# Submissions Report

## Seaside City DCP

Prepared for: Tweed Shire Council  
© GeoLINK, 2013

**Figure 1** Height in accordance with existing B11

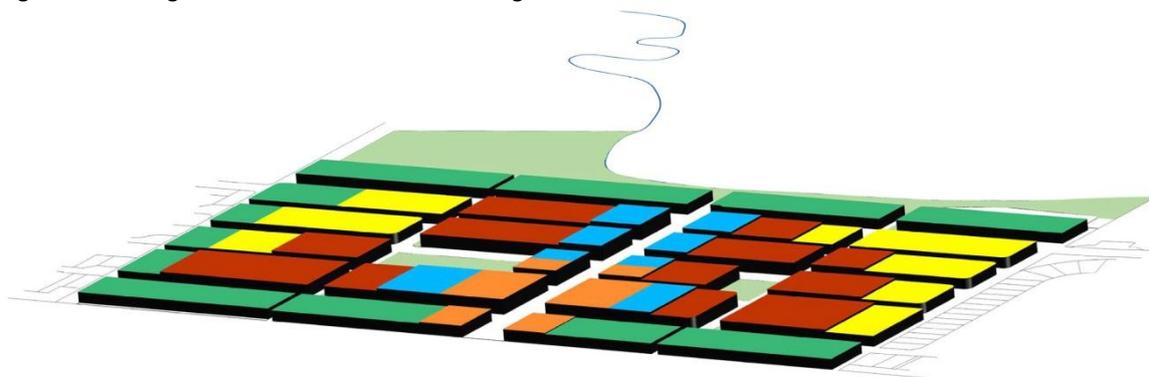
One of the key objectives of the original Section B11 was to facilitate a level of development that would result in population yields sufficient to ensure a viable Village Centre. A secondary objective was to facilitate a built form response that graduated in height towards a relatively dense and compact Village Centre, providing for a range of housing/ building forms from single to three storeys in height.

A graphic representation of this graduation in height is shown in **Figure 1**.

**Figure 2 Height in accordance with exhibited draft B11**

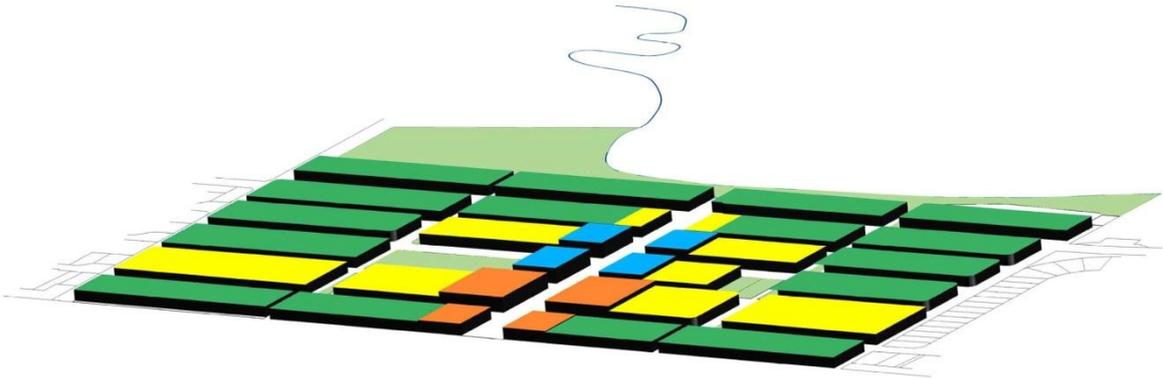
A consequence of the amendments proposed in the draft Section, as exhibited, would be to reduce the height variation across the site, with 9 m to ridgeline (maximum) across the site, except for the Village Centre and the Village Centre Fringe. A graphic representation of this scenario is shown in **Figure 2**.

Accordingly, the amendment resulted in the limitations to building height for Richtech and non-Richtech owned properties. In addition, this amendment, in effect, prohibited Residential Flat Buildings (RFBs) by virtue of confining buildings to two storeys in height. Both of these outcomes are contradictory to the intent of the original DCP amendment, which was not to reduce the development potential of landowners, rather, reduce the 'minimum' provisions which previously had to be met.

**Figure 3 Height in accordance with submissions**

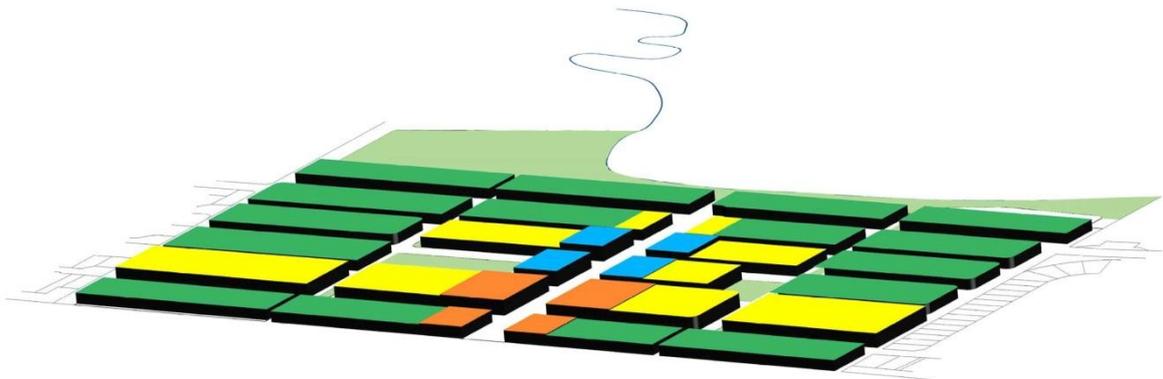
The suggested changes put forward in the submissions would provide a height graduation across the site that would be 'between' the two scenarios described above. As shown in **Figure 3**, this would allow a greater level of variation than the exhibited draft, partially maintaining the intention of the original Section.

Development to a maximum height of 11 m (to ridgeline) would not be out of character with development elsewhere on the Tweed Coast, with such development existing in Casuarina and at Salt (both directly adjoining the Seaside City City). Under the medium density residential provisions of Section A1 of the Tweed DCP, residential flat buildings of three storeys are permitted in all medium density areas of the Shire.

The amended height also re-instates the previous development opportunities afforded to landowners, except for select Richtech-owned properties, which have come at the proponents' request.

Allowing three-storey residential development in some parts of the Coastal Multi Dwellings precinct will assist in achieving the original aims of Section B11, in that it will assist in the provision of an ultimate population yield sufficient to support a viable Village Centre, and it will provide the graduation in height and density of built form from the Seaside City margins toward the Village Centre.

Three-storey development will not be inconsistent with the residential character established on the Tweed Coast and given the alignment of the lots, the height is unlikely to result in significant overshadowing issues.

It is therefore recommended that the amendments requested within the submissions be accepted and the draft Section B11 be updated accordingly.

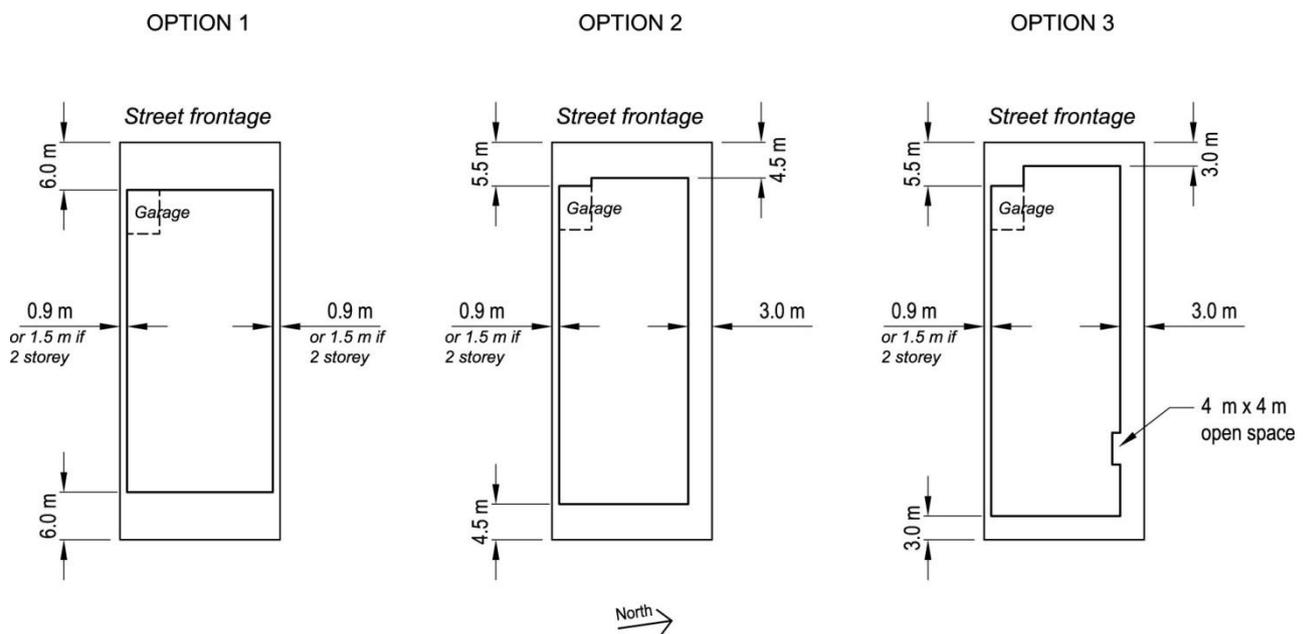
It is suggested that setbacks can be reduced, but that such reduction should be accompanied by additional design controls that will achieve increased side setback along the northern boundary of properties. This will address issues such as overshadowing and ensure that useable internal open space is provided with appropriate orientation. This is particularly achievable given that the lots at Seaside City are orientated east/west.

It is recommended, therefore, that applicants be given a choice of setback options, where reduced front and rear setbacks are available, but only where additional northside setbacks are provided. The following table outlines the setback options that are recommended across the site:

<b>Option 1</b>	<b>Option 2</b>	<b>Option 3</b>
Front	Minimum 6 m	Minimum 4.5 m	Minimum 3 m
Side	Both sides - minimum 900 mm for single storey, minimum 1500 mm for two storey and above	Northern boundary - minimum 3 m Southern boundary - minimum 900 mm for single storey, minimum 1500 mm for two storey and above	Northern boundary - minimum 3 m Southern boundary - minimum 900 mm for single storey, minimum 1500 mm for two storey and above A minimum 4m x 4m area of open space to be provided along the northern boundary.
Rear	Minimum 6 m	Minimum 4.5 m	Minimum 3m

The sketches below illustrate how these reduced setbacks might work

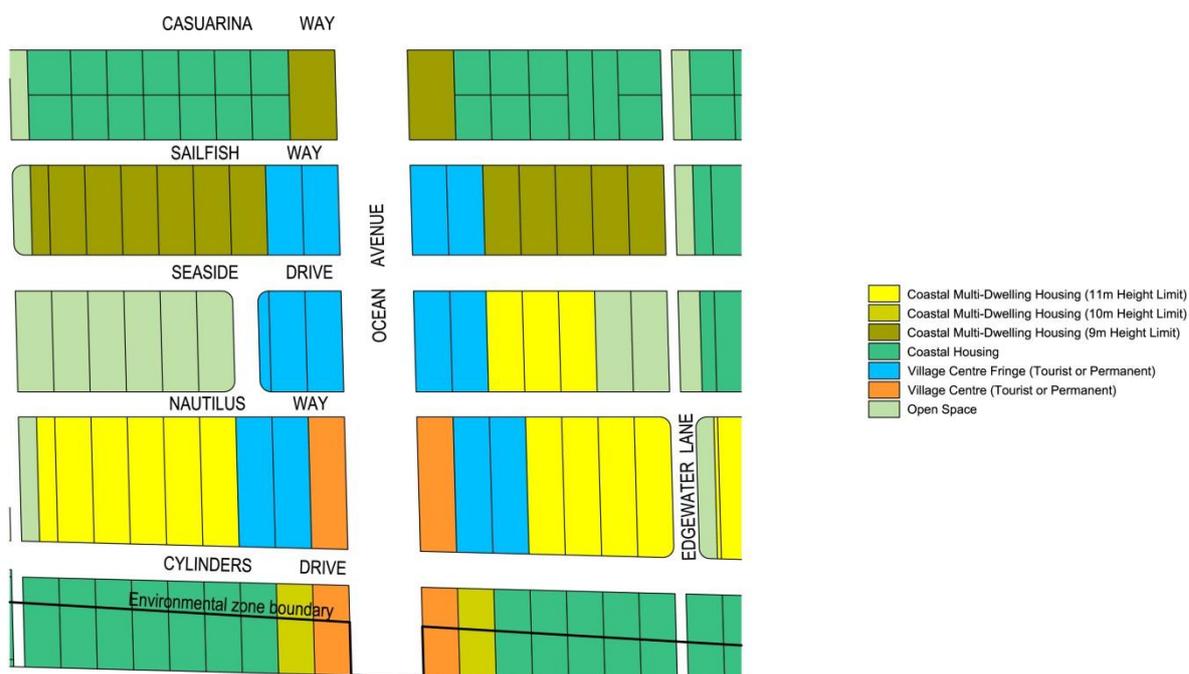
Based on this, it is suggested that B11 currently contains too much land within the Village Centre.

The location of the Village Centre remains appropriate, at this key intersection adjacent to the beachfront. It is suggested, however, that the area could be reduced to the four key allotments around the intersection, as shown below.

West of Cylinders Drive, it is suggested that the two lots 'behind' the reduced Village Centre should be designated as Village Centre Fringe (Tourist or Permanent). This will allow three-storey residential or tourist development, including such uses at the ground plane, at a density of 1 unit per 125 m<sup>2</sup> of site area. This is consistent with the Vision for Seaside City and it will ensure that a relatively dense village core can be achieved, assisting to achieve the overall Seaside City population, and supporting the viability of the anticipated retail area.

East of Cylinders Drive, it is suggested that the two allotments 'behind' the reduced Village Centre should be designated as Coastal Multi Dwelling Housing, with a 10 m maximum height limit, to support the density of the village core.

Based on the above, it is suggested that the Village Centre lots be adjusted as suggested.
